CITY OF WASHINGTON, ILLINOIS

Agenda Item: Summit Estates Section Two Amended Final Plat Approval

FINAL PLAT REVIEW CHECKLIST

**AMENDED FINAL SUBDIVISION PLAT OF
 SUMMIT ESTATES, SECTION TWO**
 A SUBDIVISION OF A PART OF
 SECTION TWENTY-NINE (29), TOWNSHIP TWENTY-SIX (26) NORTH, RANGE THREE (3) WEST
 OF THE THIRD PRINCIPAL MERIDIAN, TAZEWELL COUNTY, ILLINOIS

AMENDED FINAL PLAT

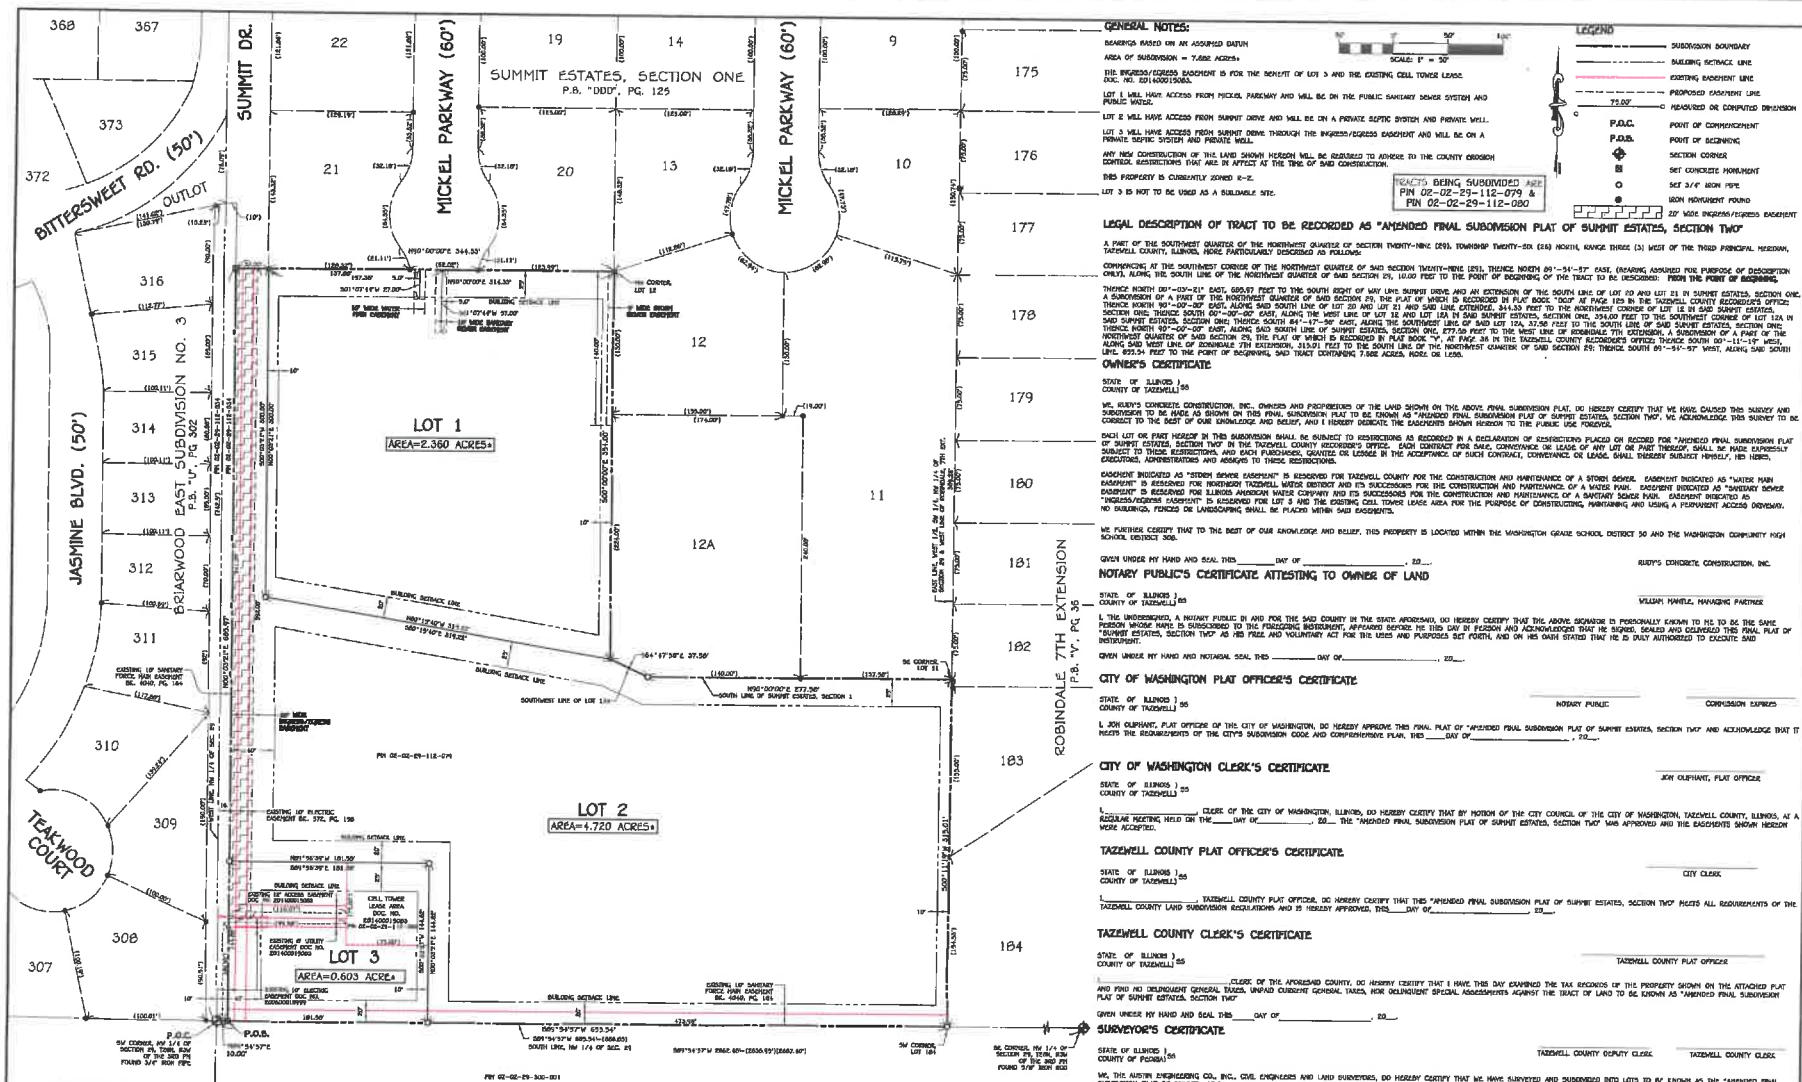
It was recently discovered that a 10' strip that was thought to have been included in the S. Summit right-of-way is actually owned by a separate private property owner. This was not discovered in the original title search in 2016. As a result, there is now 30' of right-of-way on S. Summit and not 40'. An amended final plat has been submitted to reflect this change and the location of the easement that was created for access to Lot 3 with the original plat. It slightly reduces the area for Lots 2 and 3. Other than the waiver of the lot width requirement, this plat meets the City's subdivision code regulations as well as the County's zoning code regulations. The amended final plat and corresponding checklist are attached.

Committee Discussion Summary: Staff recommends approval of the amended final plat.
